*State of New Mexico*  
**ENVIRONMENT DEPARTMENT**  
**DOE OVERSIGHT BUREAU**  
P.O. Box 1663, MS/J-993  
Los Alamos, New Mexico 87545

8 August 1997

**RE:** Department of Energy Oversight Bureau (DOE OB) Inspection Observations and Recommendations concerning NPDES outfalls scheduled for deletion through the Waste Stream Characterization Program at Los Alamos National Laboratory (LANL).

### DOE OB Inspection Observations and Recommendations

TA-40 — 06A099

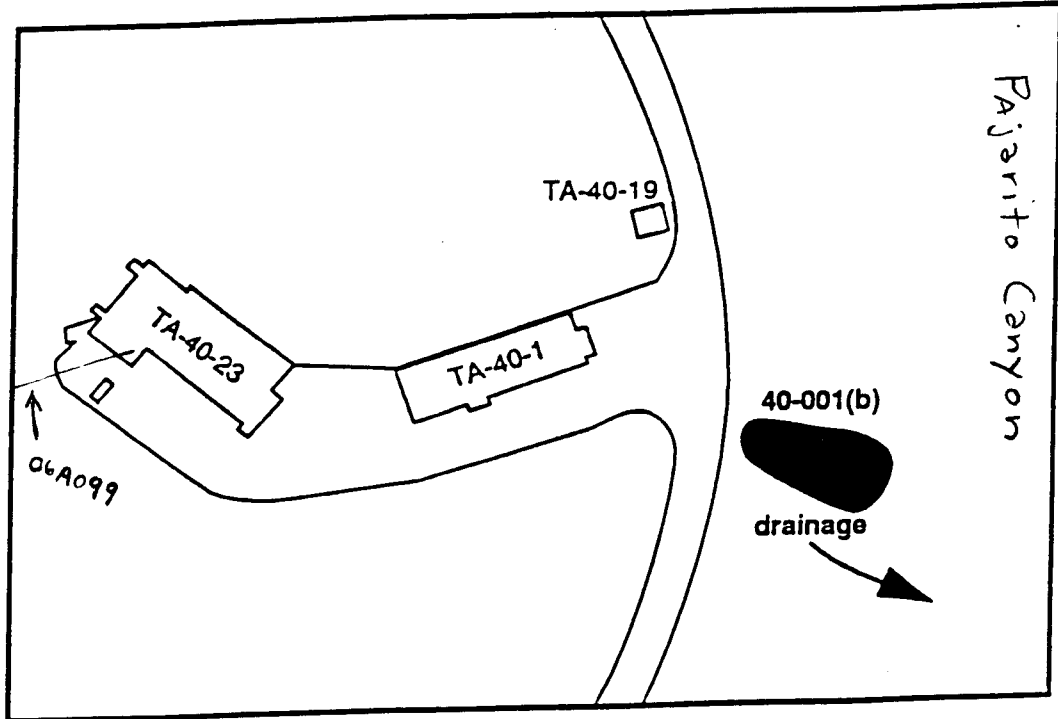
**RECOMMENDATION:** The DOE OB would recommend that this outfall be taken off the NPDES industrial permit after addressing the following concerns: The DOE OB questions why this photo-processing outfall was never listed as a PRS in the RFI Work Plan for OU-1111. Because this outfall might be a PRS and appears to be located up-gradient of SWMU 40-001(c), the DOE OB recommends that the pipe and the drainage area immediately below the outfall be investigated through the AP 4.5 procedure. If the preliminary results show a probability that soils or sediments are impacted, we recommend that this outfall not be used for storm water discharges because this would cause migration of contaminants down-gradient. In addition, we also recommend the implementation of best management practices such as run on controls in order to divert any storm water away from the outfall drainage and any PRSs directly below or down-gradient of the outfall pipe.

★ Figure 5-25. Location of 40-001(b).  
Building schematic shows  
2 roof drains discharging to  
06A099

TA-40 - 06A099

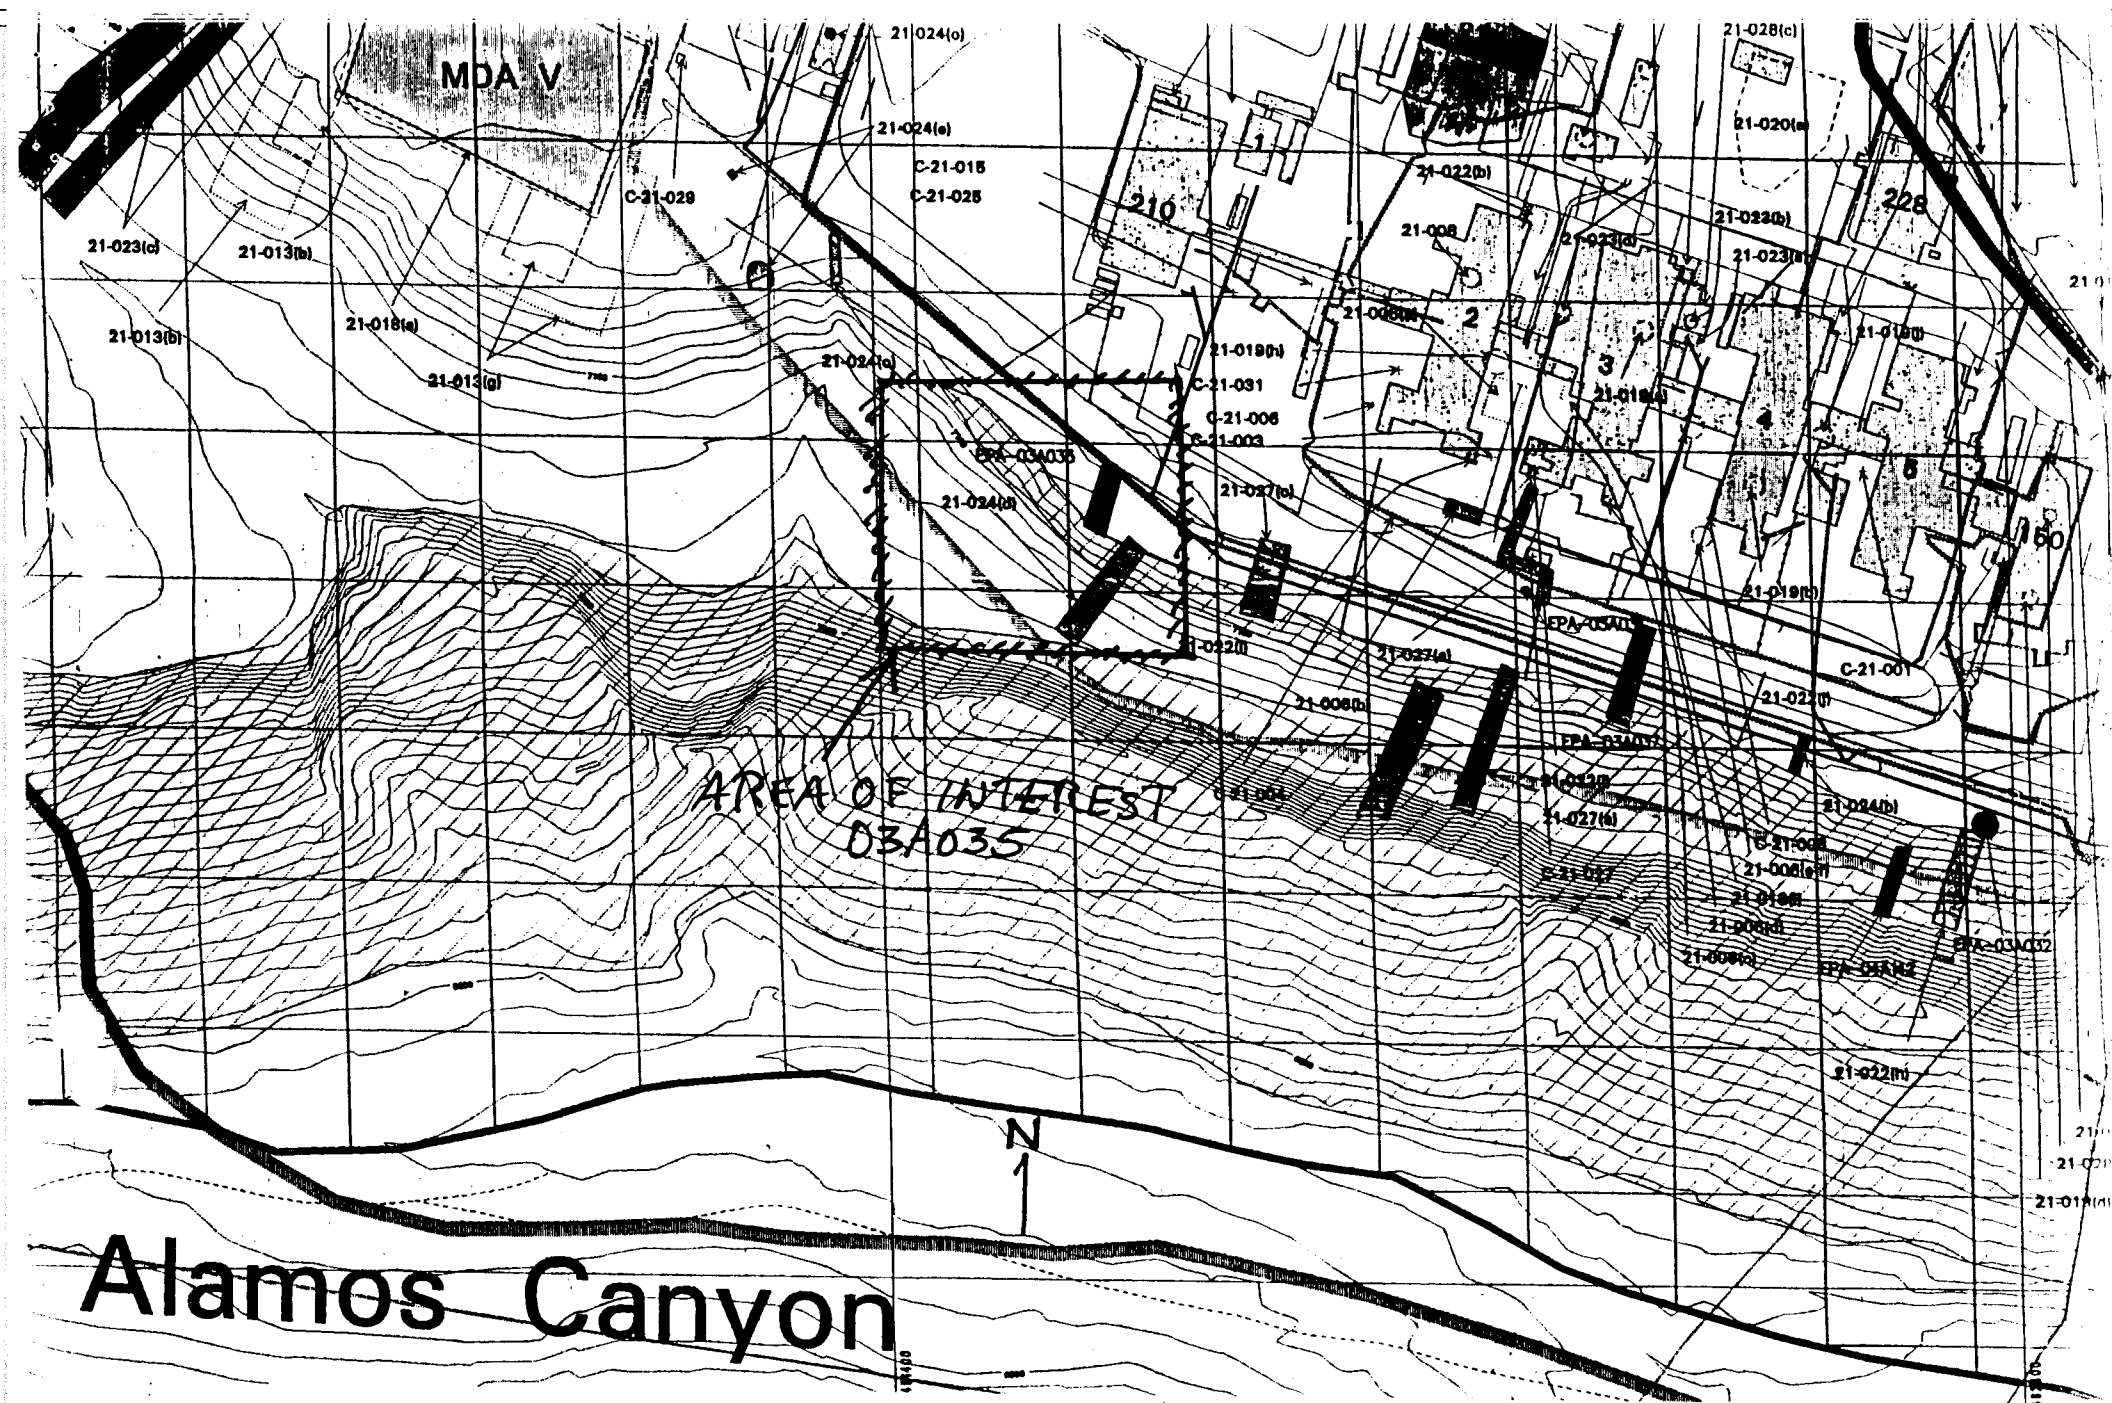
RECOMMENDATION: The DOE OB recommends that this outfall be taken off the NPDES industrial permit. Because this outfall is located up-gradient of SWMU 21-024(d), the DOE OB additionally recommends that the drainage area immediately below the outfall be investigated through the AP 4.5 procedure to see if a probability exists that PRS 21-024(d) soils or sediments might be impacted by run on from storm water discharges from this outfall. If the preliminary results show a probability that soils or sediments are impacted, we recommend that this outfall not be used for storm water discharges because this would cause migration of contaminants down-gradient. In addition, we also recommend the implementation of best management practices such as run on controls in order to divert any storm water away from the outfall drainage and any SWMUs

Fig. 5-24. Schematic field screening sampling locations for SWMU 16-029(g).

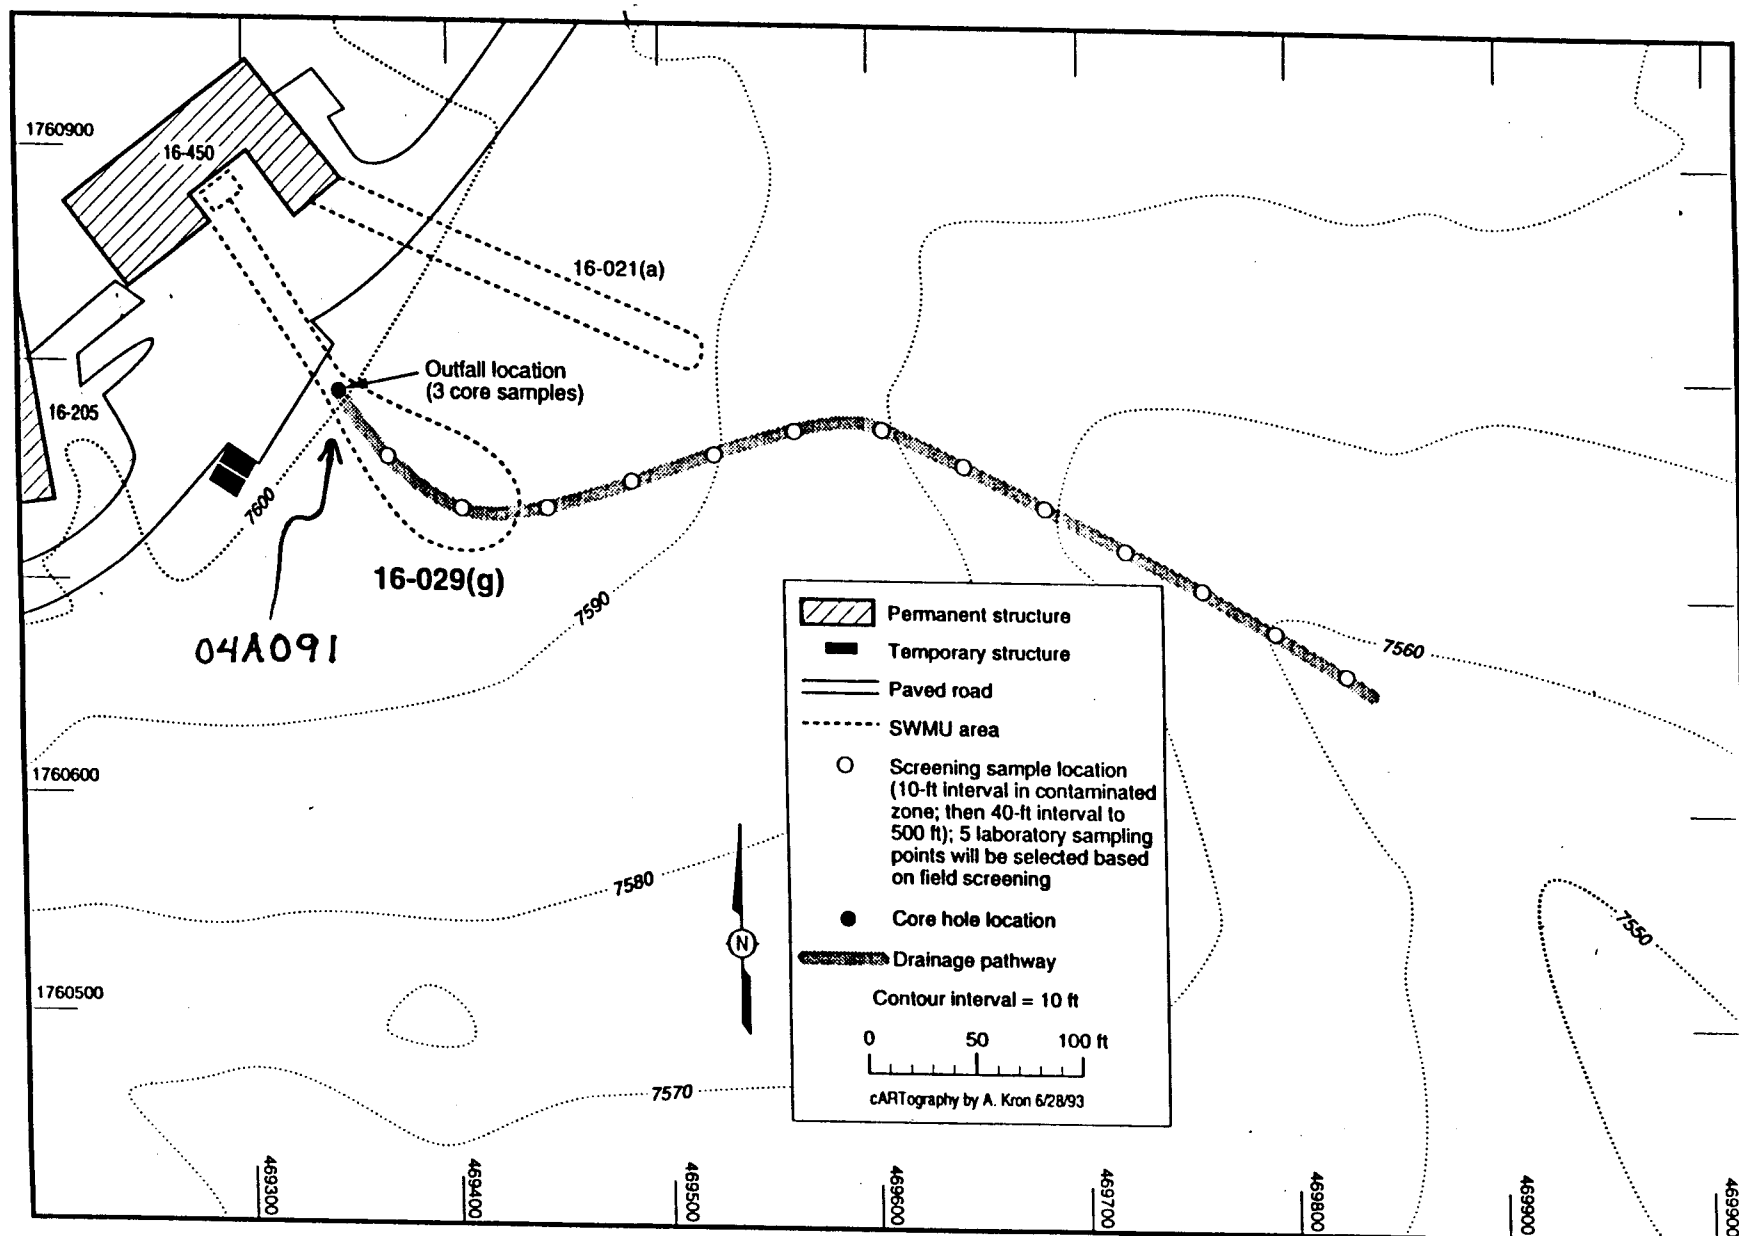
DELETION METHOD: The sump for building TA-16-450 is now plugged, with no exit outlet to the outfall, and scheduled for removal by the facility owner. The removal date is late summer 1997. The flow from the process troughs is still allowed to go to the sump, but it is now captured in large containers within the sump and periodically and properly removed as needed. The FU-3 ER Project will sample under the sump while the excavation pit is open in addition to sampling the outfall drainage area.

**RECOMMENDATION:** The DOE OB would recommend that this outfall be taken off the NPDES industrial permit after addressing the following concerns: Because this outfall is listed as SWMU 16-029(g), the DOE OB recommends that the pipe and the drainage area immediately below the outfall be investigated through the AP 4.5 procedure. Even though the probable contaminant source, the sump, is scheduled for removal later this summer, it is not known when the outfall drainage area will be scheduled for an ER investigation. See comment for 03A036, Building TA-21-152 above.
